Ballyfeeny Green Energy Project

Request for Further Information (RFI) Response Report

Roscommon County Council Ref No. 2560446

Date: June 2026

Figure 20-1: NSL's within 40m of the GCR construction works.

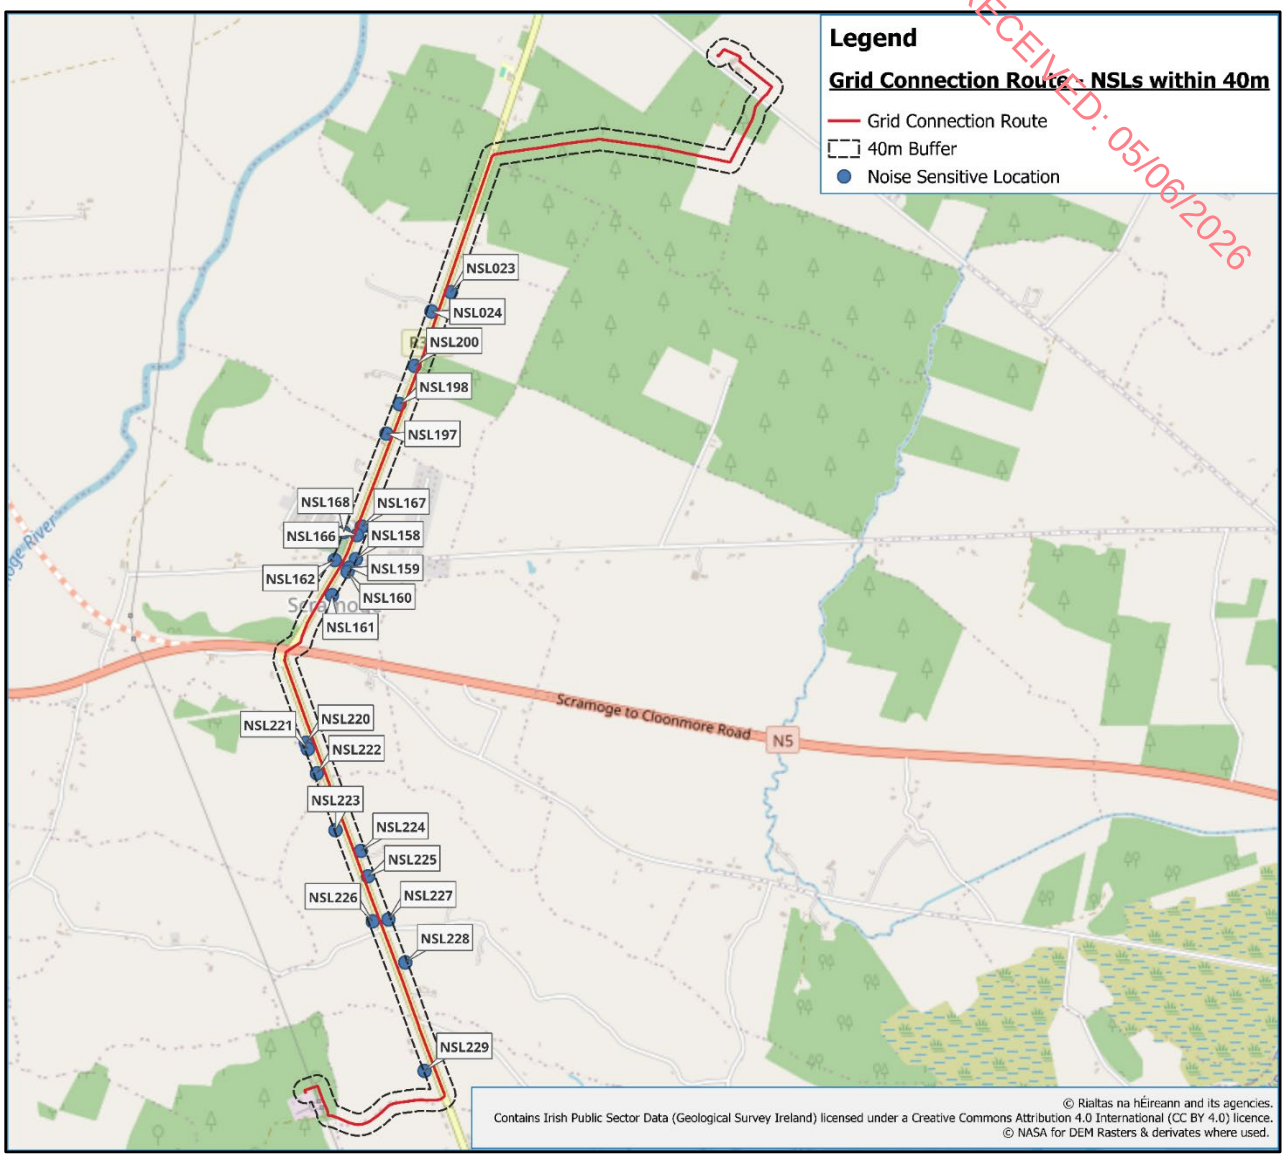
20. RFI Item 20

Although all Noise Sensitive Locations along the GCR have been considered in the impact assessment; in order to provide further clarity on the location of the sensitive receptors, RFI **Figure 20-1** and **Table 20-1** have been provided to incorporate Noise Sensitive Locations within 40m of the GCR where exceedances may occur.

The schedule of these NSLs (23no.) has been identified and mapped in **Figure 20-1**.

Furthermore, it is worth noting that NSL 167 is uninhabited and in a dilapidated condition; therefore, it is not considered further in this assessment.

Figure 21-1: HDD Compounds and nearest NSL

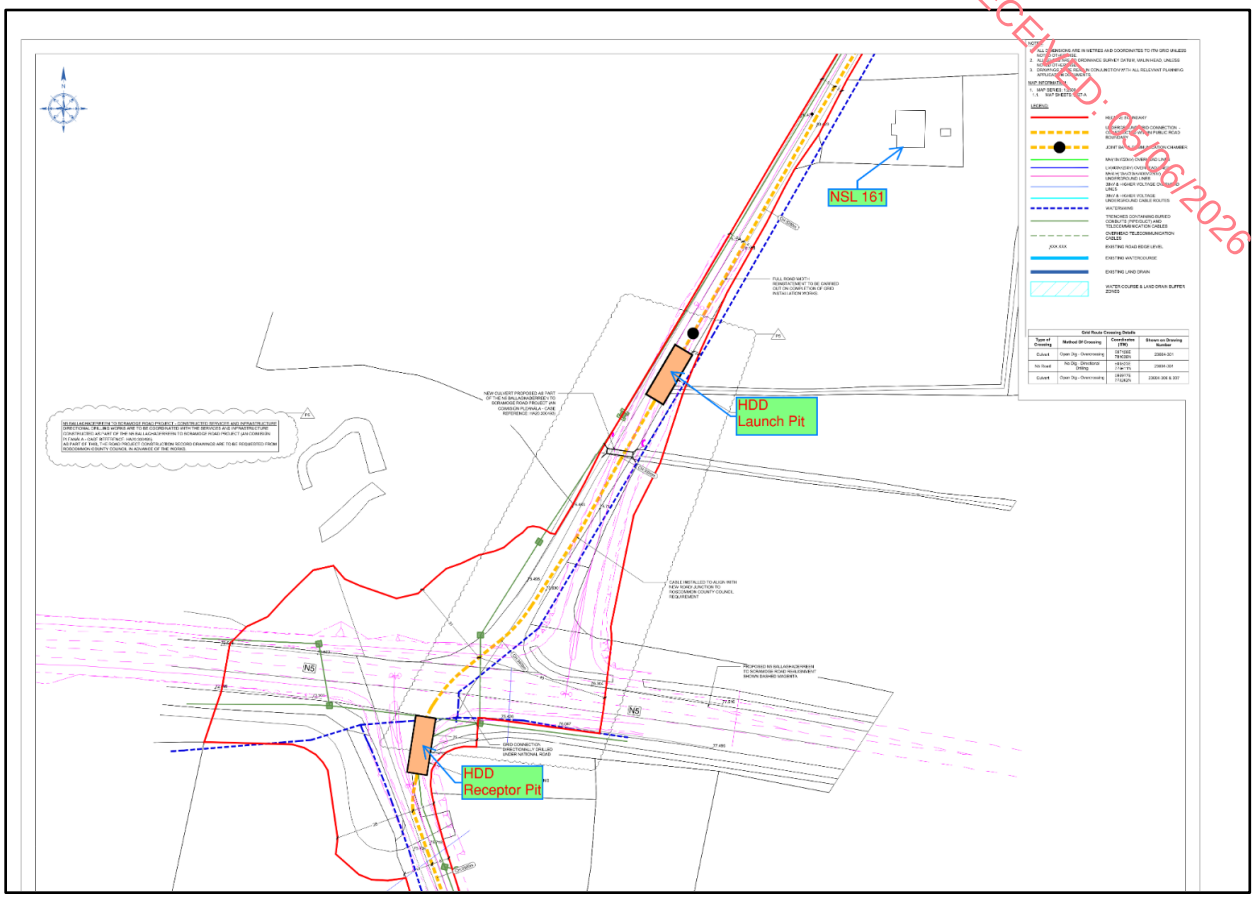
21. RFI Item 21

As a worst-case assumption the noise impact of the Horizontal Directional Drilling (HDD) was assessed in **EIAR**, **Volume 2**, **Chapter 10 – Noise and Vibration**, **Section 10.6.2 Construction Phase** at a distance of 80m to the nearest NSL. However, following engagement with the Roscommon National Roads Regional Office (RNRRO) relating to **RFI Item 5**. **Planning Drawings 23604-304** and **23604-562**, have been updated and submitted as part of this response, and are included within **RFI Appendix 1.1 – Planning Drawings**.

Planning Drawing 20604-562 with the revised location of the HDD sites and the nearest NSL indicated is provided for clarification in **Figure 21-1**.

The HDD consists of 2no. sites – the Launch pit and the Receptor pit. The Launch pit contains the noise sources as set out in within the EIAR - **Chapter 10**, **Table 10-23**: **Indicative HDD Noise Emission Levels**.
